Re: GMD5 recommendation  
concerning Hays/Russell  
R9 Ranch change applications

Re: Hays/Russell/R9 Ranch Proposed Municipal Well Locations

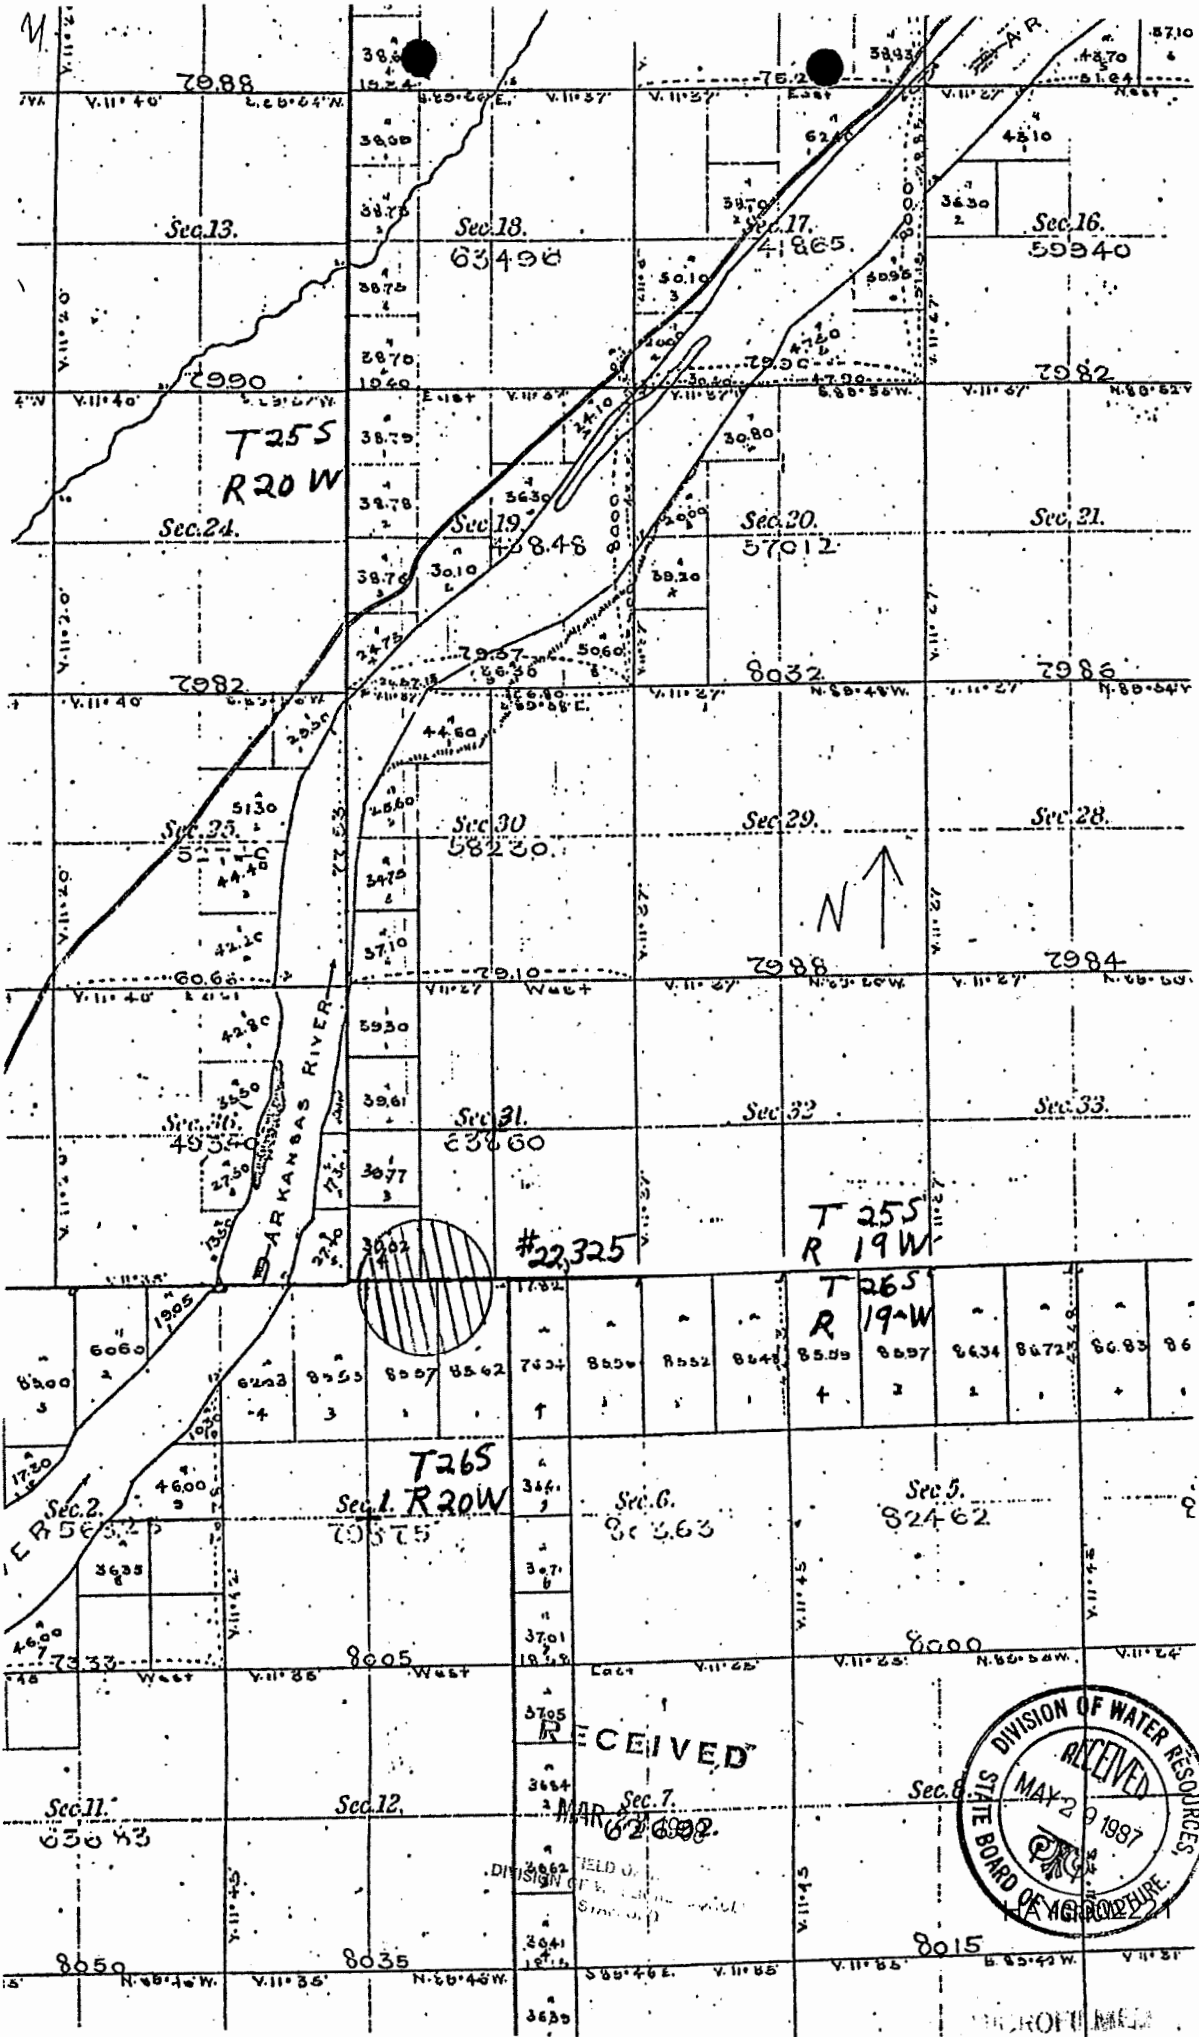
However, the distances North and West of the Southeast Corner of each Section are not accurate. The distances in Table 3 are the distances from the Section lines rather than from the Southeast Section Corners.

The distances are different because, as shown in the attached images, the Sections are not perfectly square and North/South (T25S/T26S) and East/West (R19W/R20W) corrections lines intersect in the middle of the Ranch.

Assuming the accuracy of the KGS PLSS Sections layer, which was also assumed for the previous descriptions, Mr. Clement calculated the distances North and West of the Southeast Section Corners and the UTM NAD83 coordinates for each well. The distances of each proposed well location from the Section Lines, from the Southeast Section corners, and the differences are shown in the attached table.

The Revised Municipal Well Locations table below has the corrected descriptions for the 14 proposed Municipal Wells. These locations will be included in the Amended Transfer Application and in each of the Amended Change Applications when filed.
